- Windows

- Same window specs as Staudenmeier?
  - Throughout entire project?

stucco w/  
weep  
screed  
and curb

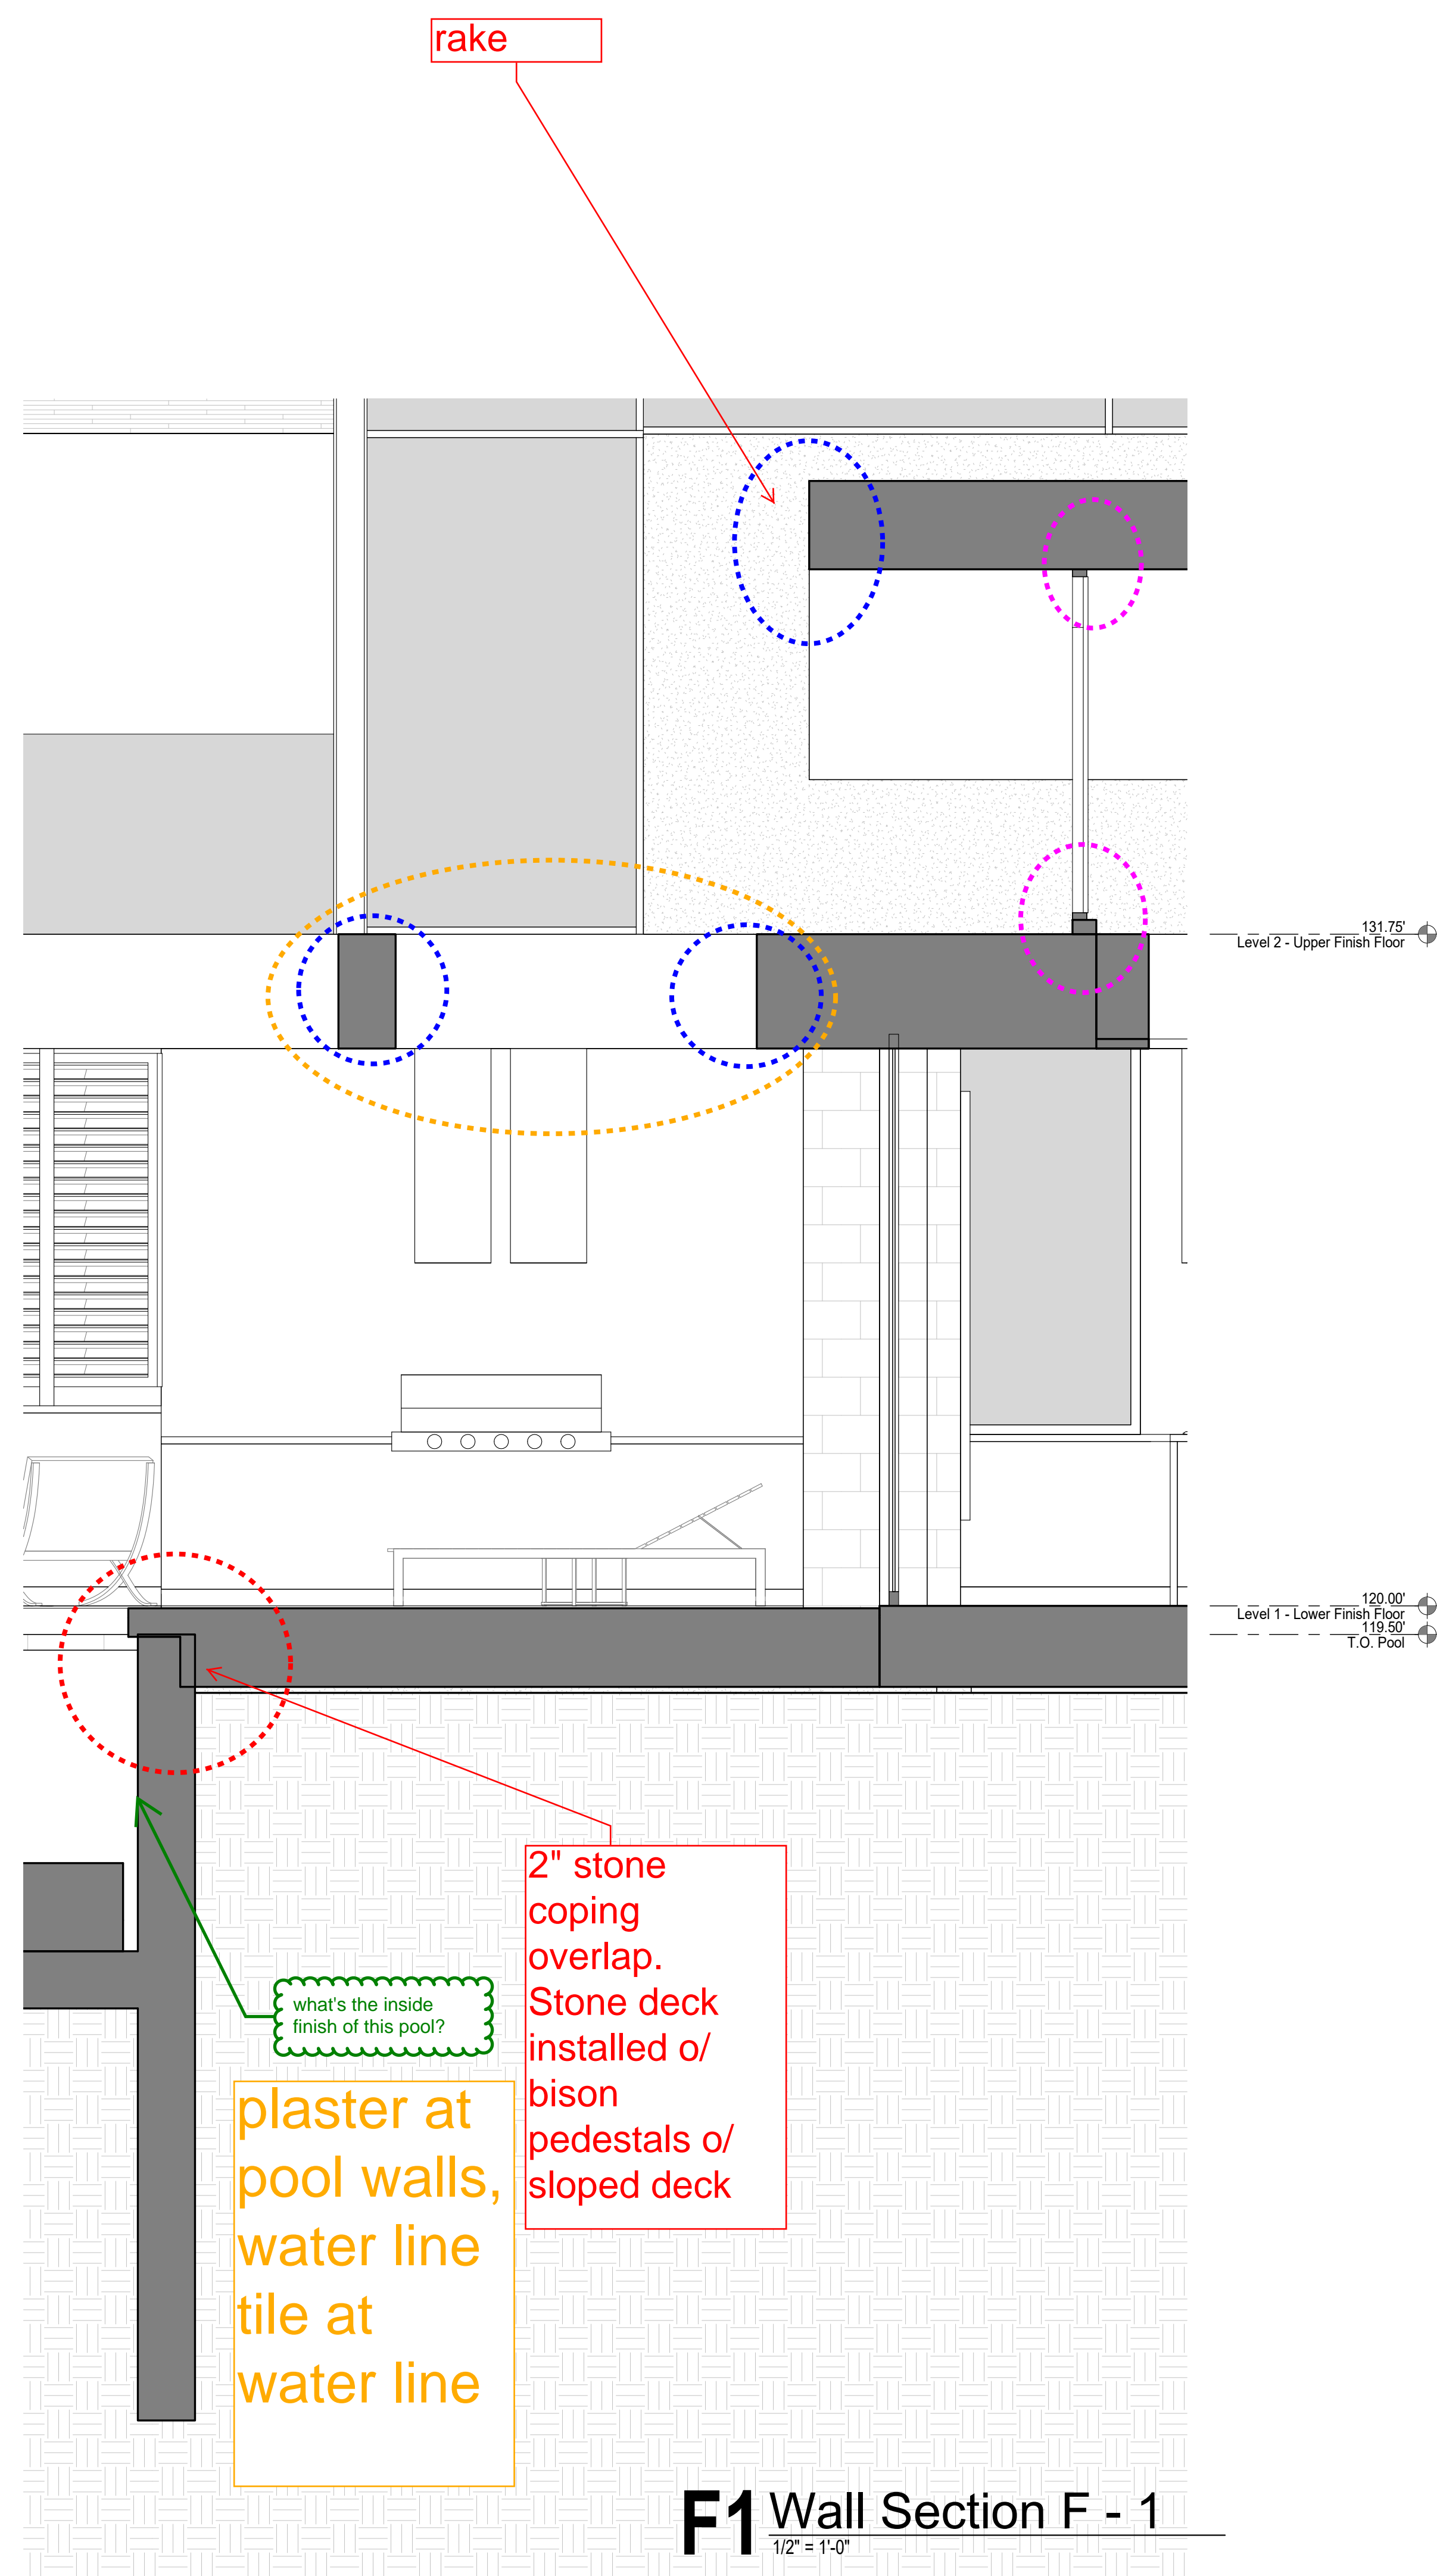
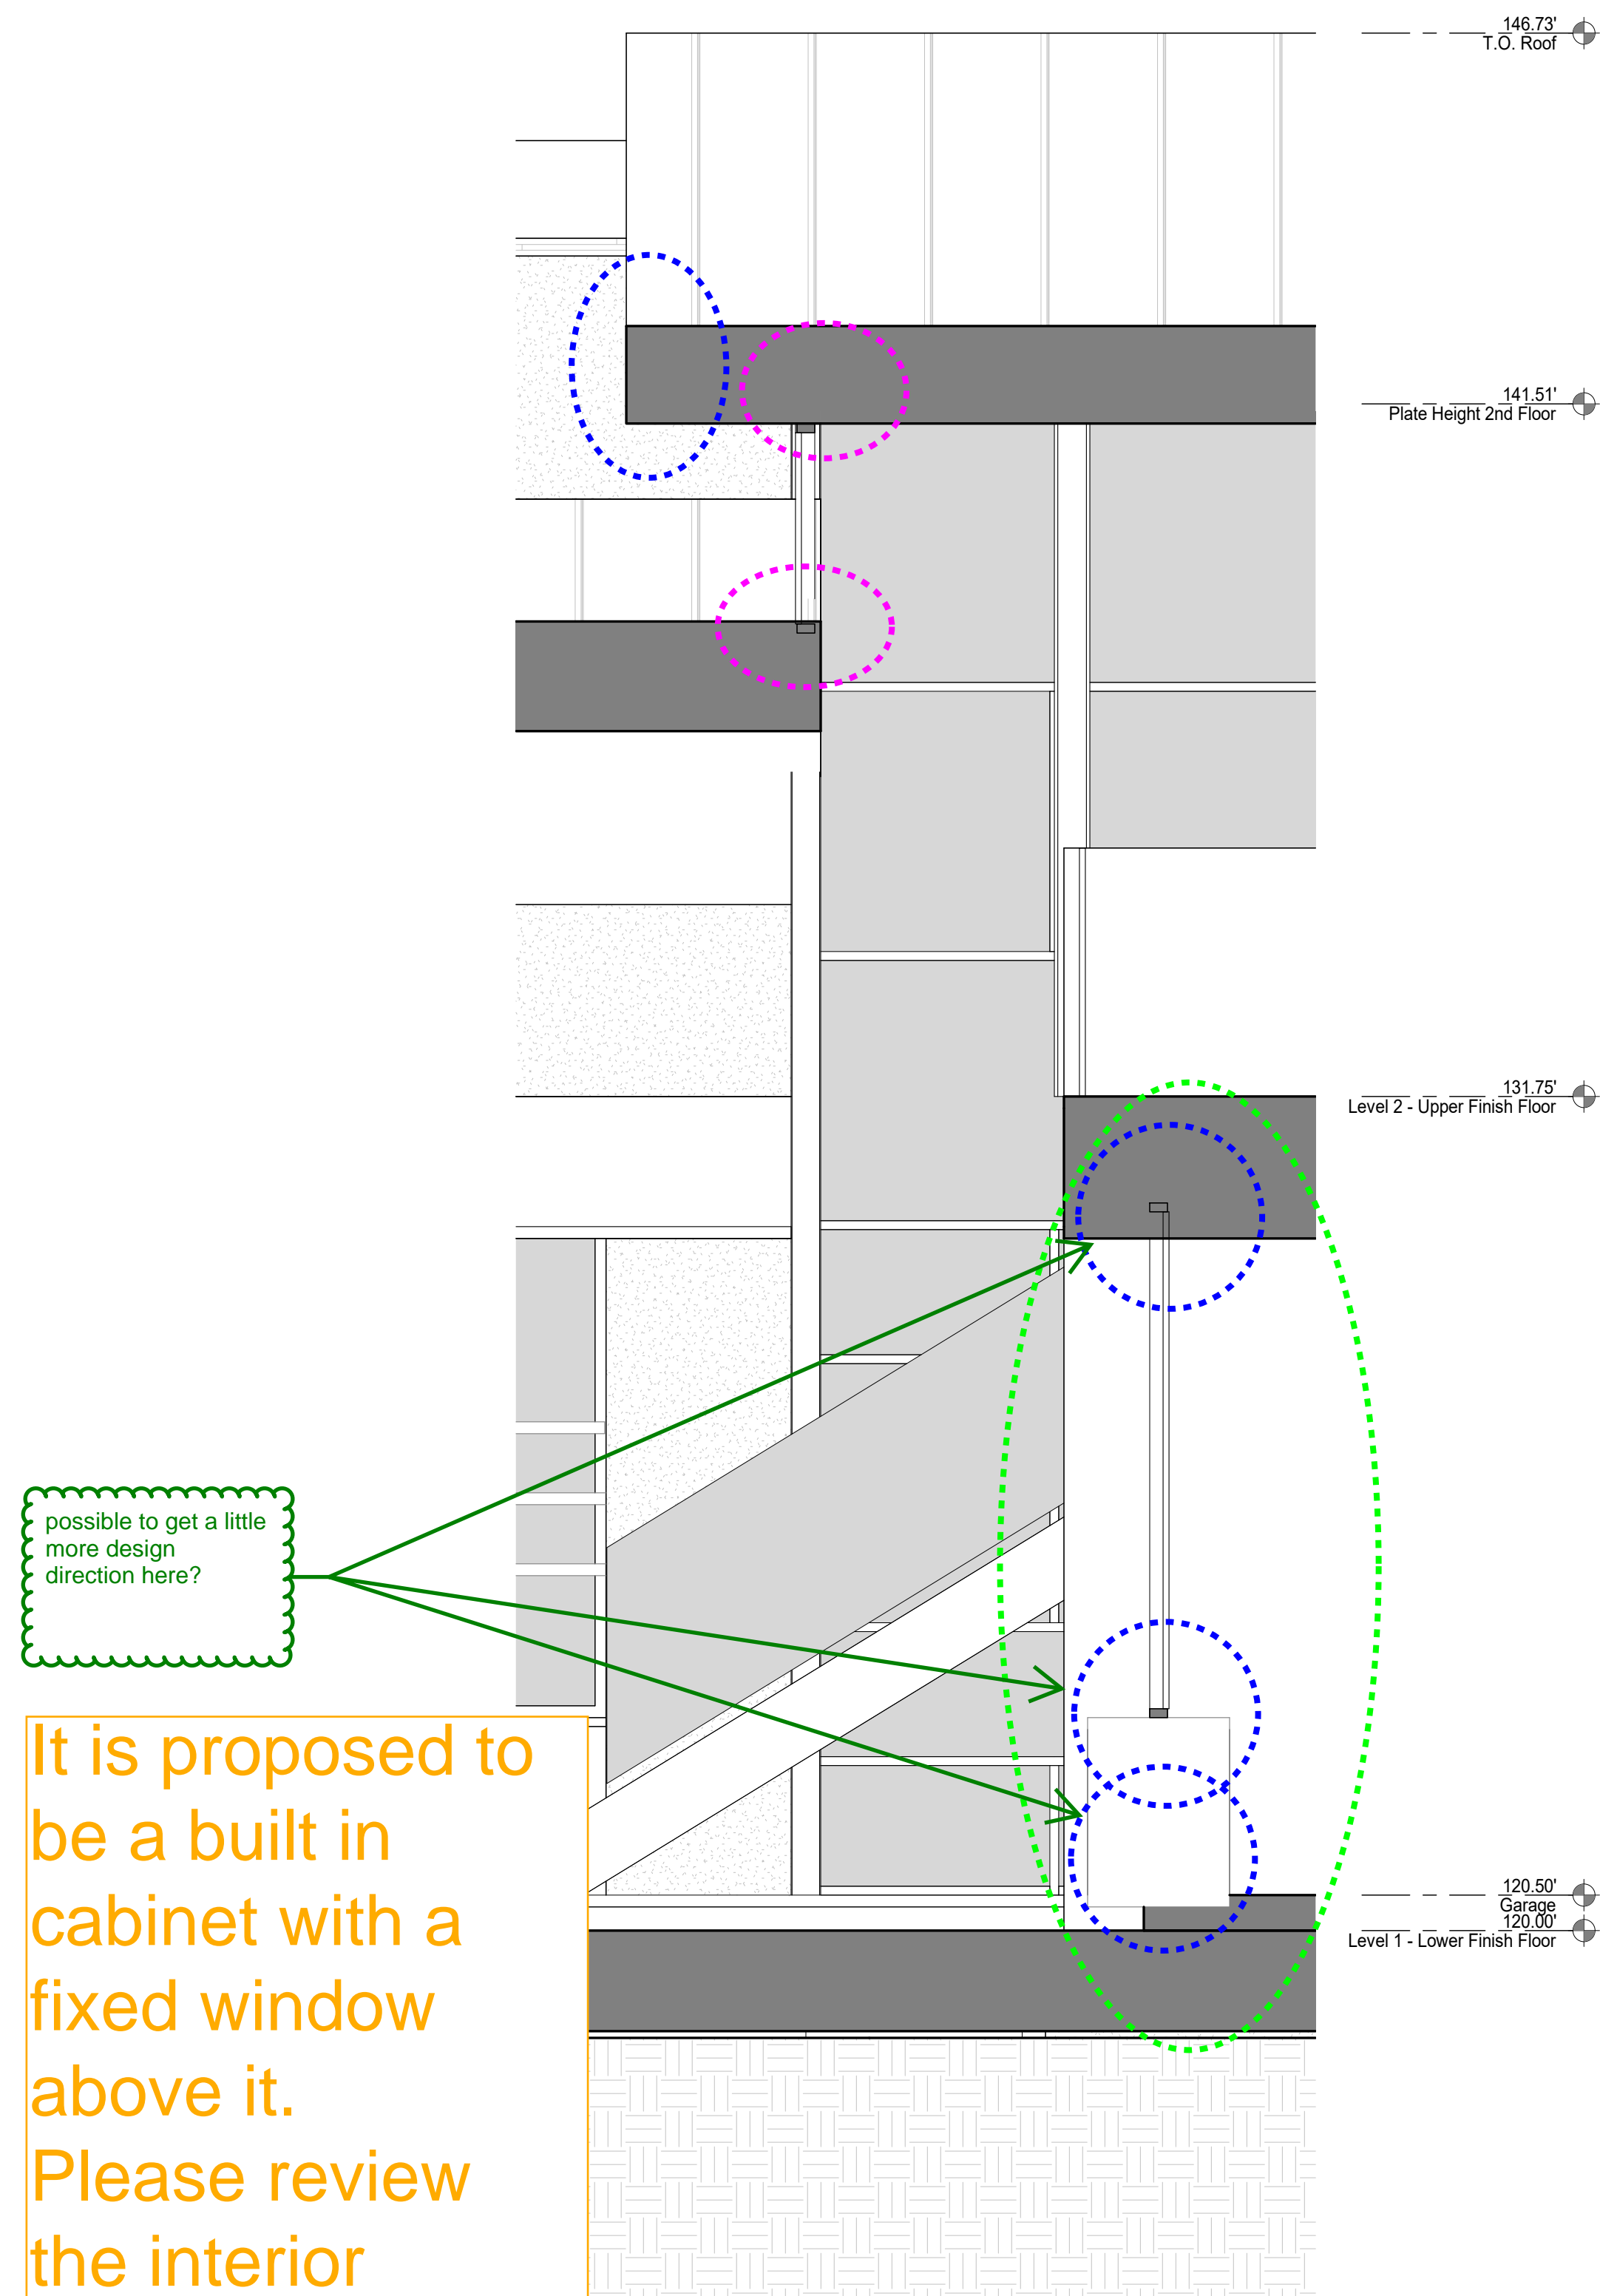
stucco to hide stone  
tile. stone tiles/  
buzon pedestals/  
West coat deck  
coating (sent you a  
link) O/ framing

at the edge, do you  
see the stone tile?  
or does the  
stucco/gypsum  
board hide the  
stone?

the revit roof object  
has this as 'Gypsum  
Wall Board'  
Is that correct?  
Or stucco?

were you envisioning  
this split stone over  
a CMU backer wall?  
Or just stacked stone  
w/ mortar?

footing?

stucco @  
exterior  
Now  
corrected  
in the new  
model

will  
confirm  
with  
structural
